# Regulatory Committee

Date of Meeting	16 March 2017
Officer	Andrew Martin – Service Director Highways & Emergency Planning
<b>Subject of Report</b>	Dorchester Transport and Environment Plan (DTEP) Proposed Turning Movement Bans at South Gate Junction
Executive Summary	<p>In 2003 the County Council agreed with Dorchester Town Council and West Dorset District Council to prepare a plan to enhance the public realm and reduce the negative impacts of traffic in Dorchester. As the plan was developed maintenance and improvement works at various locations in Dorchester were put on hold. In late 2013 public consultation was held on a scheme proposal, which would provide one-way traffic flow in the High Street, but this was not found to be publically acceptable.</p> <p>In September 2014, Cabinet resolved that elements of DTEP that include deferred maintenance and improvement works, plus some environmental enhancements, but exclude one-way traffic in the High Street, be progressed. This included replacement of the existing pedestrian crossing signal equipment around South Gate Junction and linking of the individual crossings to reduce traffic delays. It also included relocating the pedestria

### Appendix 2 – Consultation Plan Showing Proposed Banned Movements

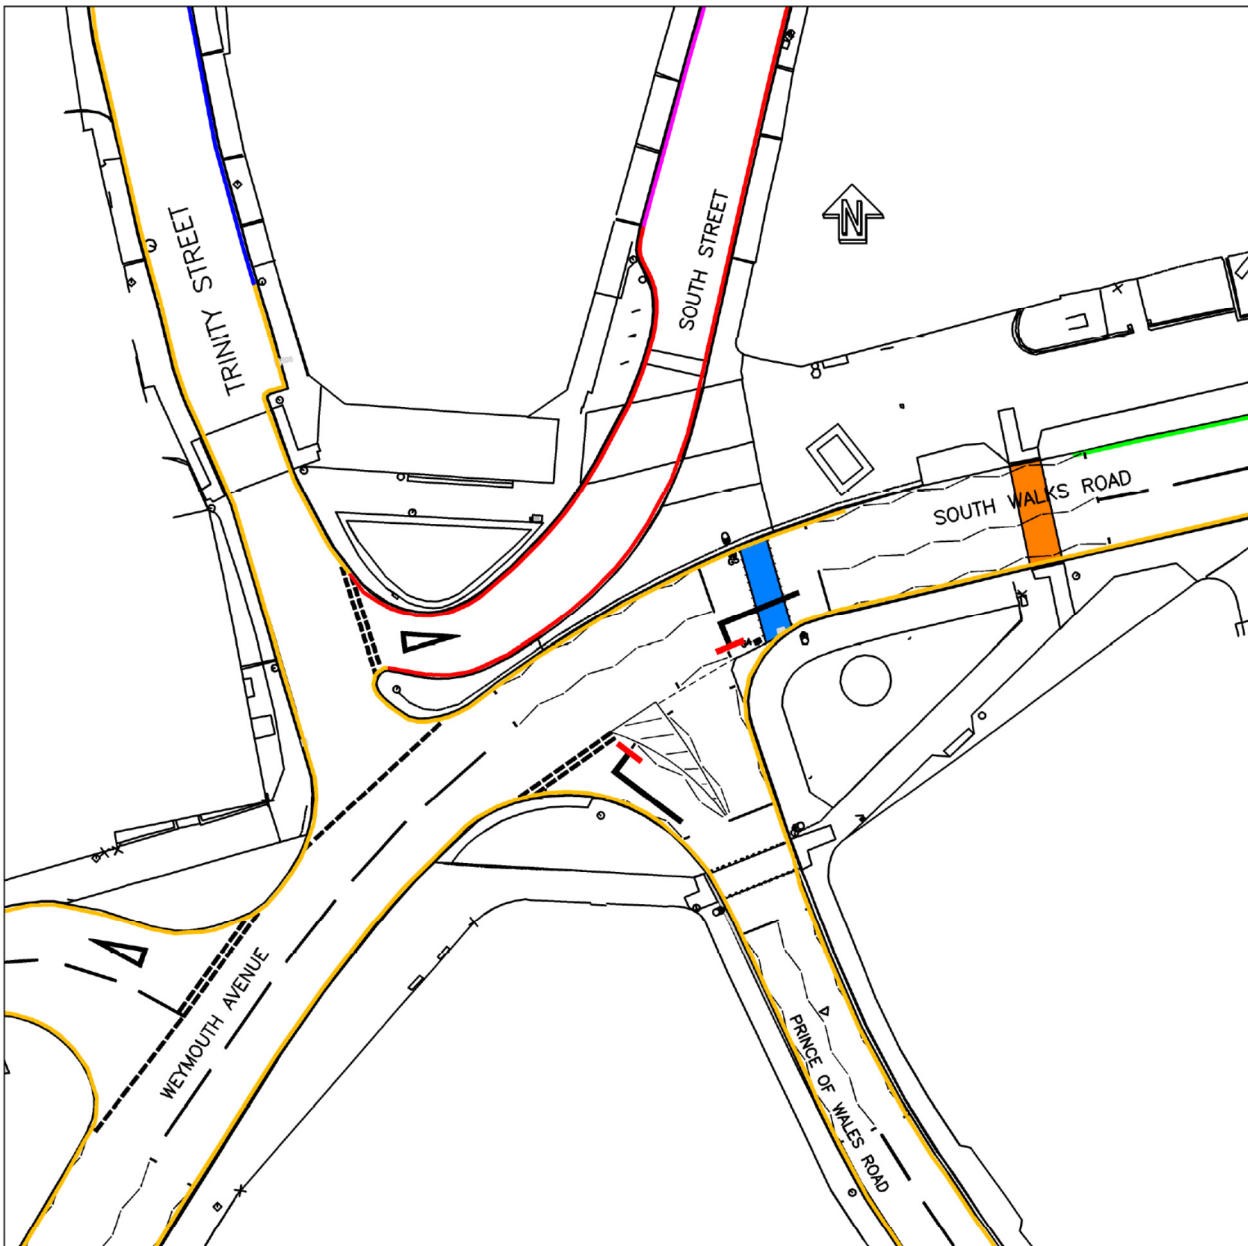
Respondent and Address	Summary of Response
Resident of Southfield House, South Walks Road, Dorchester	Is concerned at the relocation of the pedestrian crossing. Considers that the proposals will decrease air quality at her flat; is opposed to the loss of grass on the corner of Prince of Wales Road and South Walks Road; considers that traffic turning right into Prince of Wales Road will suffer additional delay; considers the loss of her view of “young mothers and their children” on the crossing will increase “loneliness of the elderly”.
Resident of Orchard Street, Dorchester	Objects to the proposal. Can understand the reason for the right turn from Prince of Wales Road being banned but not the left turn in. Doesn't like puffin crossings and doesn't think this is the best solution for pedestrian safety.
Resident of Copper Crescent, Dorchester	Is concerned at the expenditure which he considers is unnecessary. Is also concerned that the alternative route via Culliford Road is unsuitable for the additional traffic.

- 4.5 The objector is also opposed to the use of puffin technology and prefers the old style pelican crossings.
- 4.6 The respondent from Copper Crescent considered that the expenditure was unnecessary. The respondent was also concerned at the suitability of Culliford Road as an alternative route, noting that they considered turning into it off South Walks Road as difficult and right turns out of it as dangerous.

- 4.7 The respondent from Southfield House supported the use of puffin technology, but raised the following concerns: -
- additional car fumes at their flat;

- loss of grass verge on the corner of Prince of Wales Road and South Walks Road;
  - delays to traffic;
  - potential littering;
  - insufficient space for pedestrians to wait;

- loss of view of the crossing increasing “loneliness of the elderly”;
  - the money could be better spent elsewhere, e.g. to provide better pedestrian facilities at Maumbury Cross.

- 5.1 The design rules for signal controlled pedestrian crossings require that they should not be placed within 20 metres of a junction where vehicles can turn onto the crossing. This is a safety measure so that a vehicle can complete its manoeuvre and stop safely at the crossing. In order to relocate the crossing, it is therefore necessary to ban right turns out of Prince of Wales Road.

- 5.2 To achieve a crossing as close as possible to the direct pedestrian route, as requested by consultees, the radius of the left turn from South Walks Road into Prince of Wales Road has to be substantially reduced and this would make it difficult for small vehicles and impossible for larger vehicles to make this manoeuvre safely. It is for this reason that the left turn is proposed to be banned.

- 5.8 Some of the grassed area on the corner of Prince of Wales Road and South Walks Road will be lost, to provide footway access to the new pedestrian crossing, but a substantial part of it will remain and the flower bed within it will be unaffected.

- 5.10 If littering occurs the provision of bins will be rationalised.
- 5.11 The proposed crossing will be slightly wider than the existing and there should be adequate space for pedestrians to wait.
